Date	Rev.	Status or Amendment
28/08/17	A	Issue for DA Amendment

Pursuant to section 197 of the *Planning and Development Act 2007*, approval is sought to amend development approval No. 201630289 dated 13/12/2016 as described at **Attachment A.**

Project: Canberra Labor Club Belconnen Hotel
Blocks: 8+9 | Section: 48 | Division: Belconnen
Drawing Title: Ground Floor Plan
Job No.: 16_35 | Drawing No.: DA-A101 | Scale: 1 : 100@A1 | Rev.: F

Drawing Title: Plant Area Floor Plan

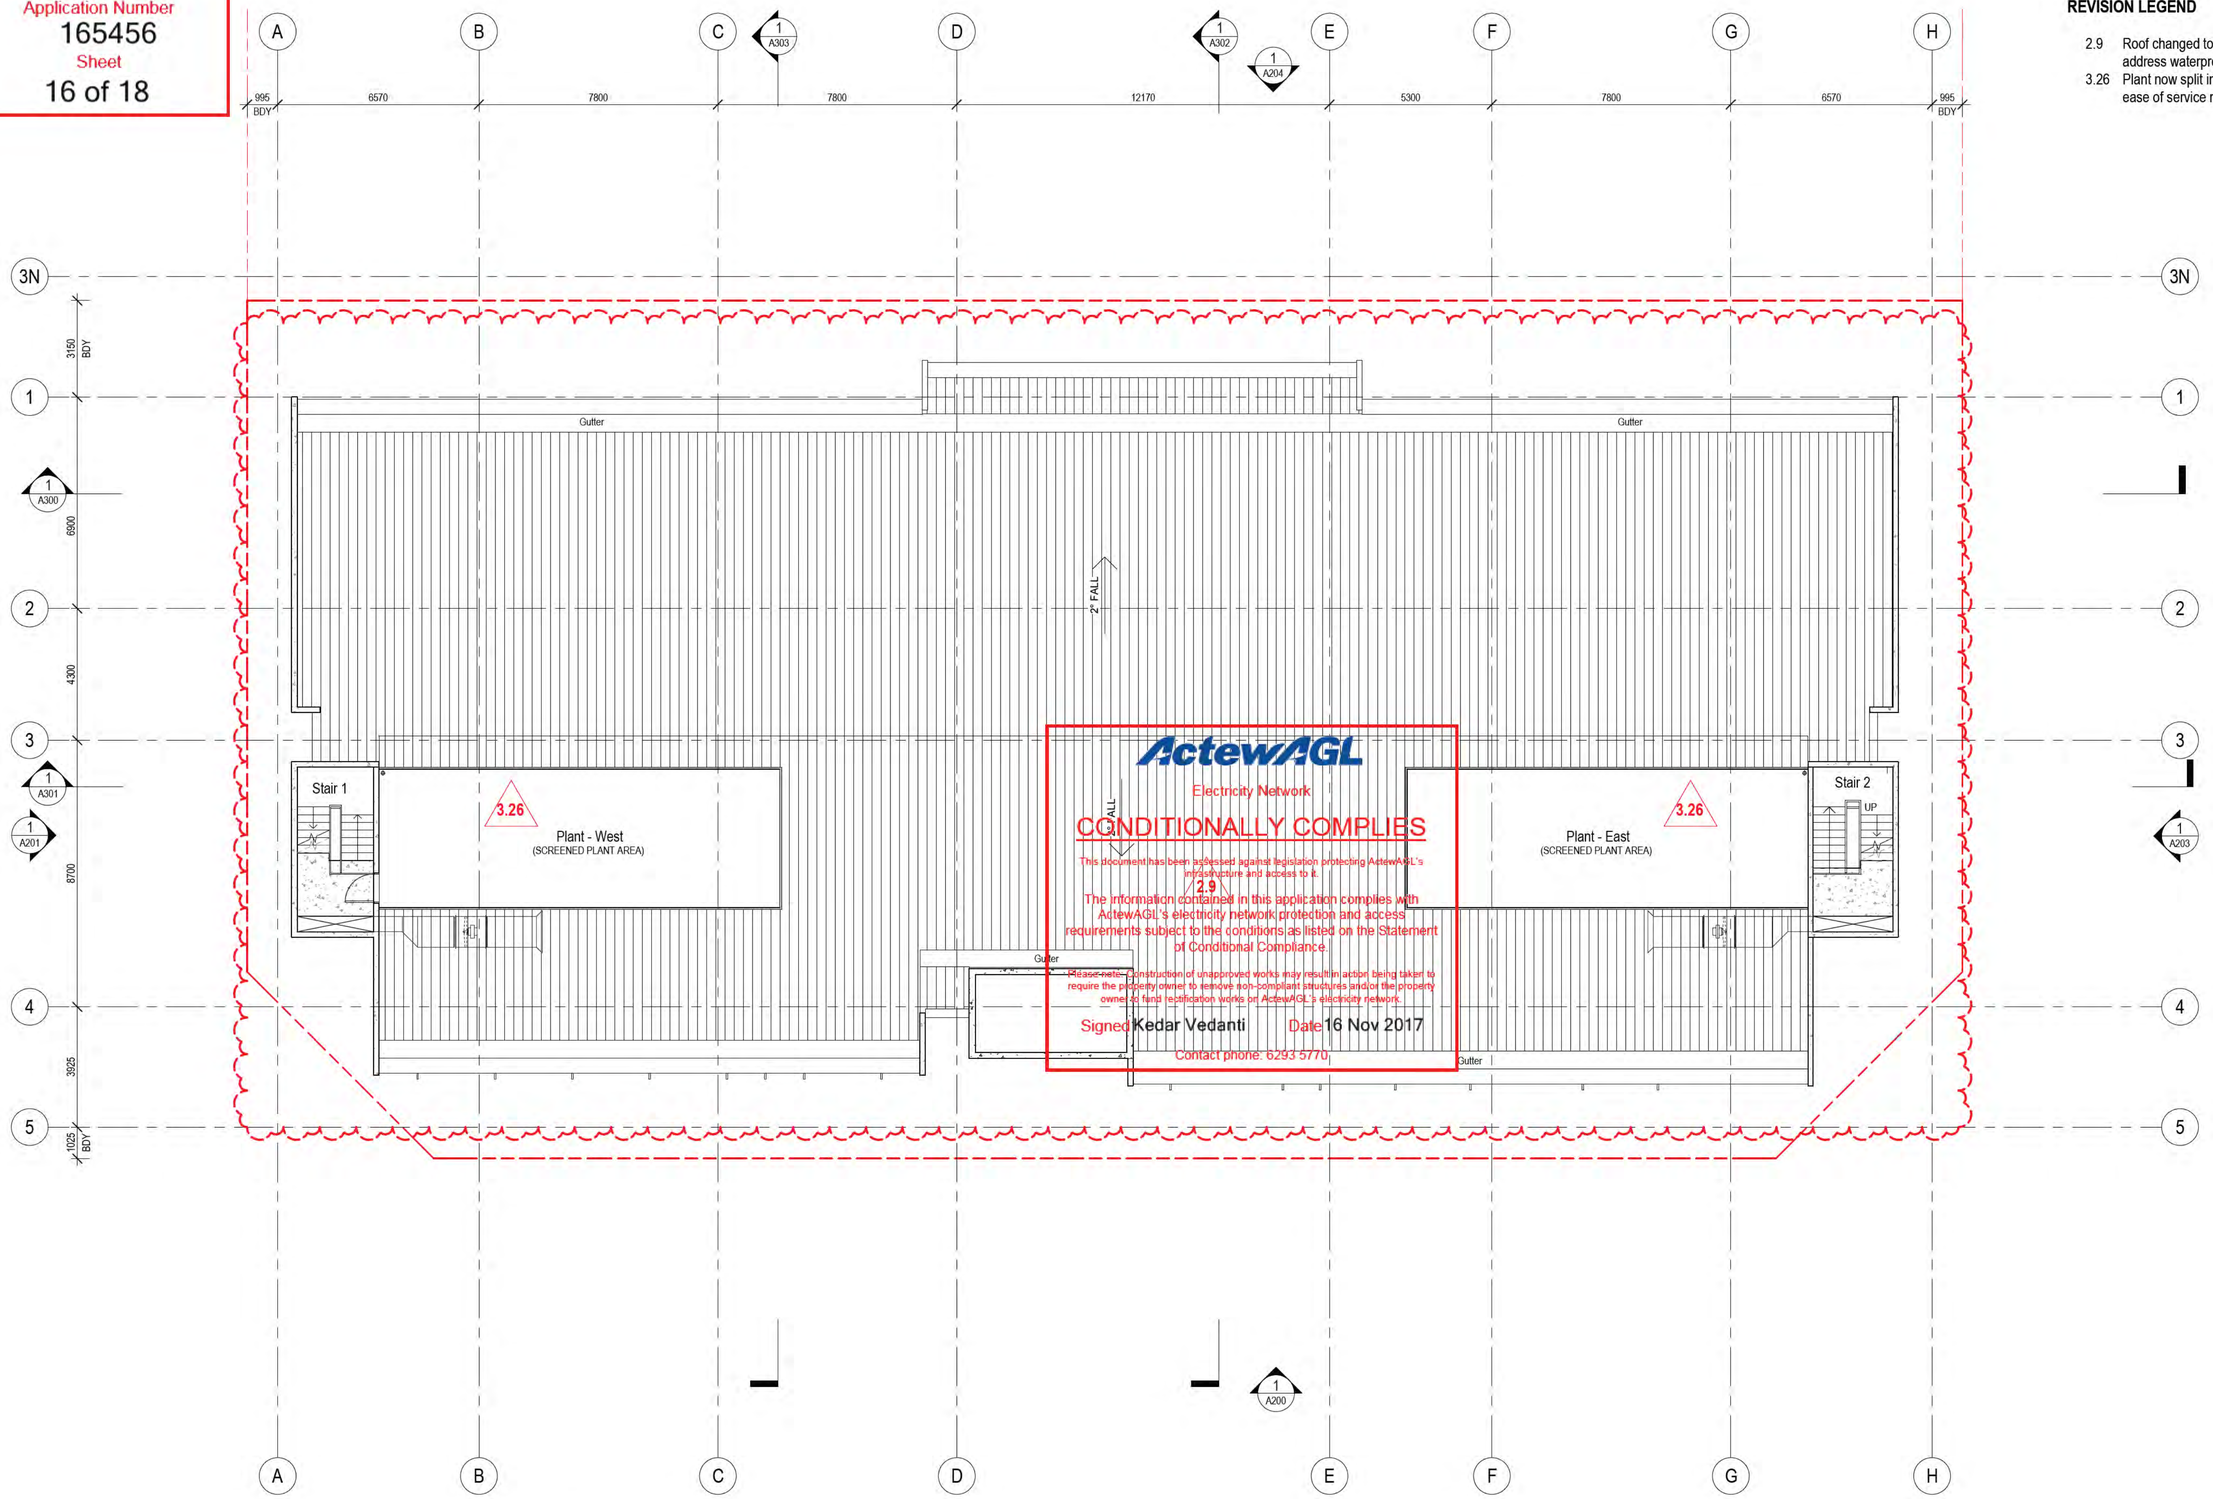
2.9 Roof changed to a metal deck roof with a centre ridge to address waterproofing concerns.
3.26 Plant now split into two areas to meet egress requirements and ease of service reticulation.

Drawing Title: Ground Floor Plan

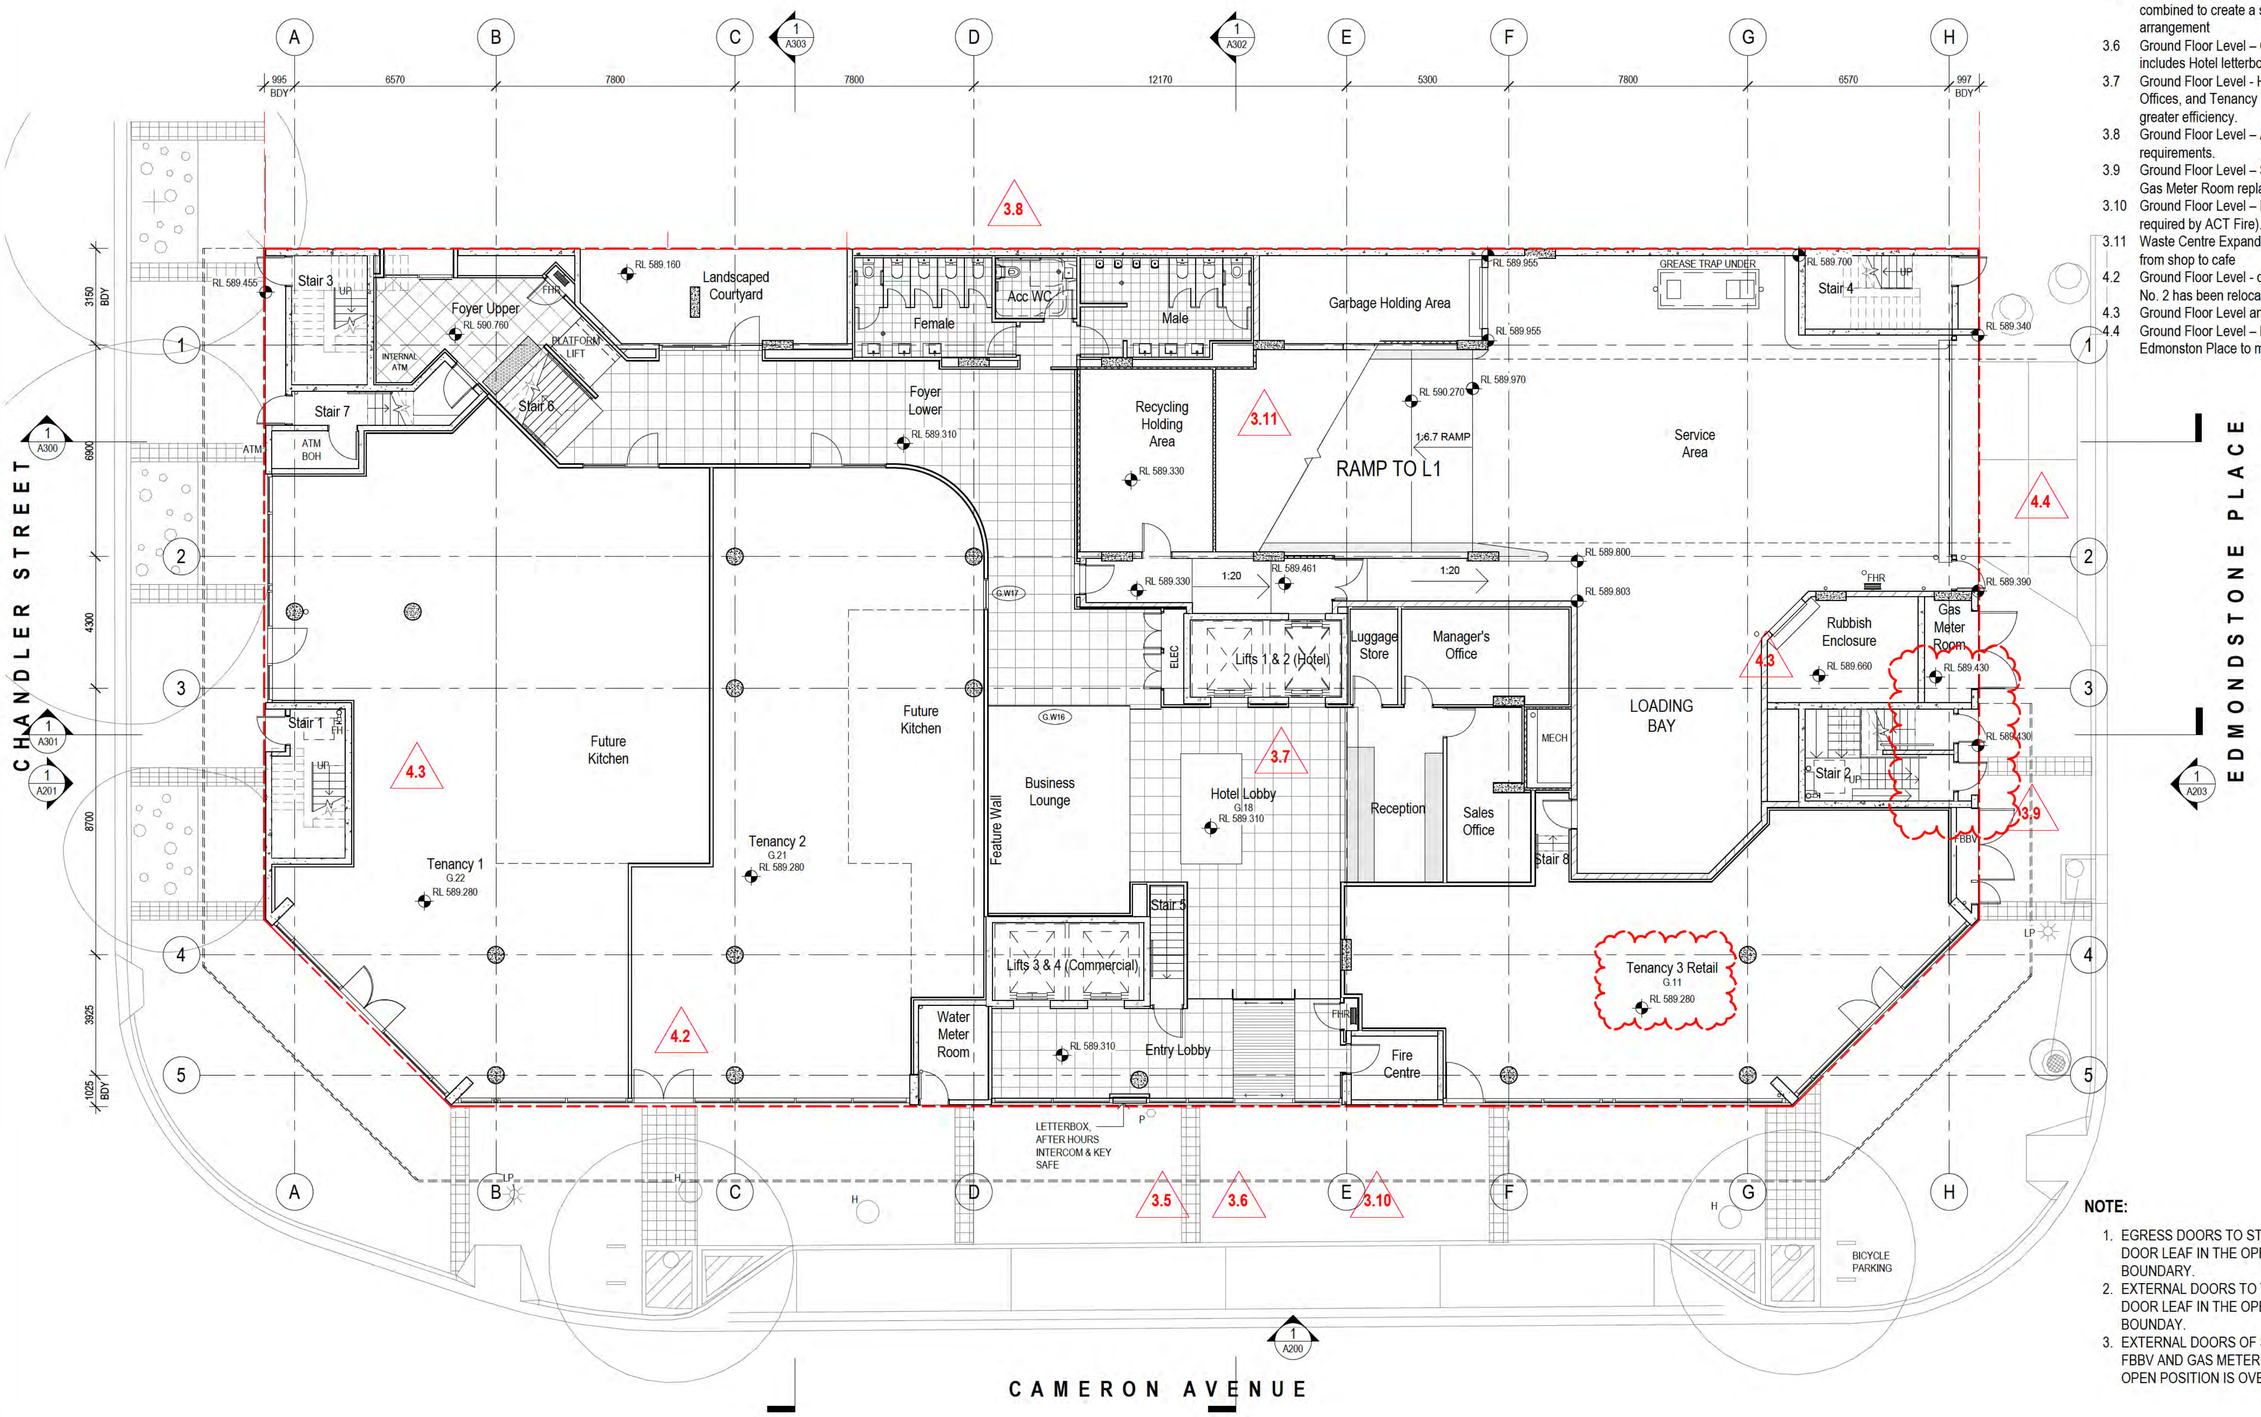
1. **The entry door to the stair 2 on the Edmondstone Place must be amended to open inside the block.**
2. **The applicant must submit a revised drawing.**

I have spoken to the TCCS officer this morning and he is ok for me to approve the DA if you provide the revised plan showing Stair 2 door swing contained within the subject block boundaries.

This is the only outstanding item. So please email the revised plan directly to me and I can approve the DA. Can you also have the plan annotate retail against Tenancy 3 as previously agreed.

- 3.7 Ground Floor Level - Hotel Reception, Luggage Store, Hotel Offices, and Tenancy No. 3 have been replanned to achieve greater efficiency.
- 3.8 Ground Floor Level – Amenities area increased to meet BCA requirements.

- 3.9 Ground Floor Level – Sprinkler Valve Room deleted, FBBV and Gas Meter Room replanned to improve service reticulation.
- 3.10 Ground Floor Level – Fire Centre external door deleted (not required by ACT Fire).

- 3.11 Waste Centre Expanded due to change to Tenancy 3 change from shop to cafe
- 4.2 Ground Floor Level - door from Cameron Avenue to Tenancy No. 2 has been relocated so as to meet AS1428 requirements.

- 4.3 Ground Floor Level and Levels 1 - 3 – Stair Nos. 1 - 2 added.
- 4.4 Ground Floor Level – New door added from Service Area along Edmonston Place to meet fire egress requirements.

Please find attached a copy of the revised plan as requested.
Note that the plan has been revised so that the Stair 2 door swings as per all the others at the ground floor level. The reference to 'retail' has also been added to Tenancy 3.

1. EGRESS DOORS TO STAIR 1,2,3,4 AND SERVICE AREA - THE DOOR LEAF IN THE OPEN POSITION IS OVER THE SITE BOUNDARY.
2. EXTERNAL DOORS TO TENANCY 1,2 AND 3 (PIVOT DOORS) - DOOR LEAF IN THE OPEN POSITION IS OVER THE SITE BOUNDAY.
3. EXTERNAL DOORS OF SERVICES (WATER METER ROOM, FBBV AND GAS METER ROOM) - THE DOOR LEAFS IN THE OPEN POSITION IS OVER THE SITE BOUNDARY.
